Service Bulletin

Bulletin No.: PI1091

Subject: Warm Air Exhausting from Driver and/or Passenger Front Seat Back into 2nd Row Seating Area Causing Occupant Discomfort

Models: 2014 Chevrolet Silverado 1500
2014 GMC Sierra 1500
Equipped with Heated and Cooled Seats - Driver and Passenger Front (RPO KB6)

3636141

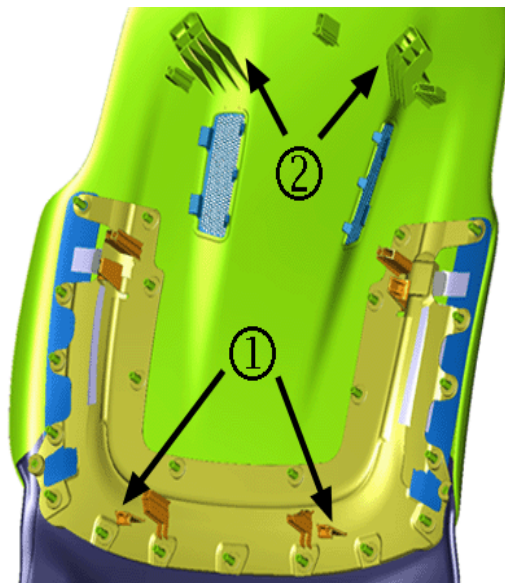
Some customers may comment on warm air exhausting from the driver/passenger front seat back into the 2nd row seating area, causing occupant discomfort.

The cause of this condition may be that during cooled seat operation, a direct flow of warm air exhausts from the upper seat back ventilation heating/cooling blower.

3636144

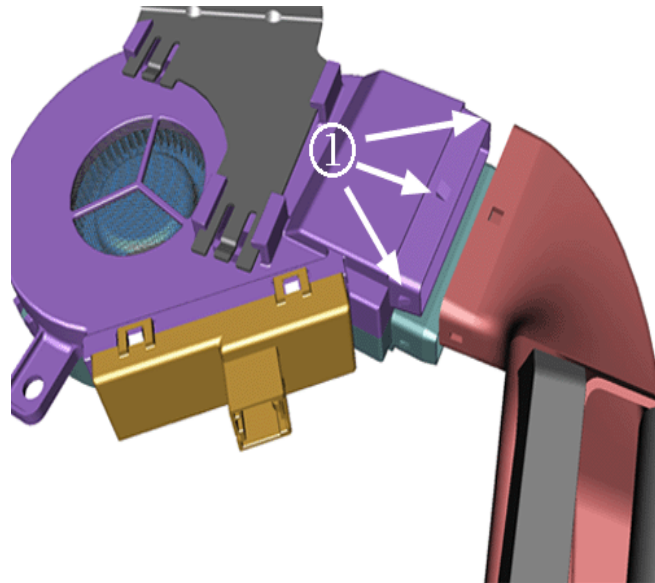
It has been found that removal of the exhaust duct (1) on the upper seat back ventilation blower allows for a less direct air exhaust and disperses the warm air more thoroughly within the seat back cushion. Remove the upper ventilation blower duct from BOTH the driver and passenger seats using the following steps:

Caution: To help avoid damage to the seat back finish panel, after detaching the lower bungee clips, carefully lift the bottom of the finish panel high enough for the lower retainers (1) to disengage from the seat frame. Once the lower retainers are released, tilt the finish panel to one side, then the other, to disengage the upper retainers (2).

1. Starting on the driver or passenger front seat, remove the front seat back cushion finish panel. Refer to Front Seat Back Cushion Finish Panel Replacement in SI.

3636147

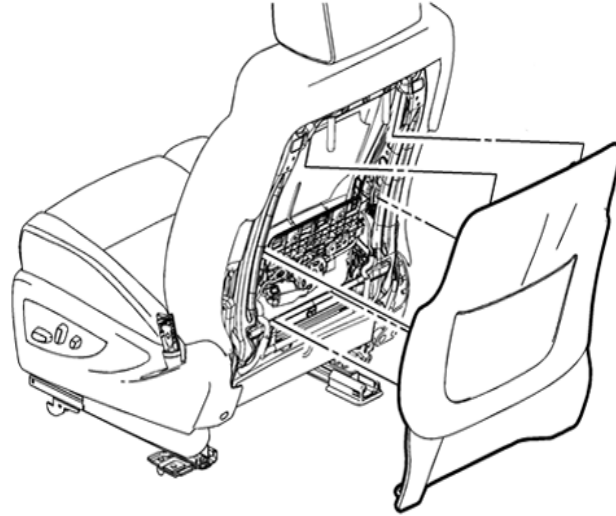
2. Locate the ventilation blower exhaust duct. Depending on the vehicle, the duct may look like either example shown in the graphic above.

3. Grab and twist the ventilation duct to release the top and side retaining tabs (1), and remove the duct from the vehicle.
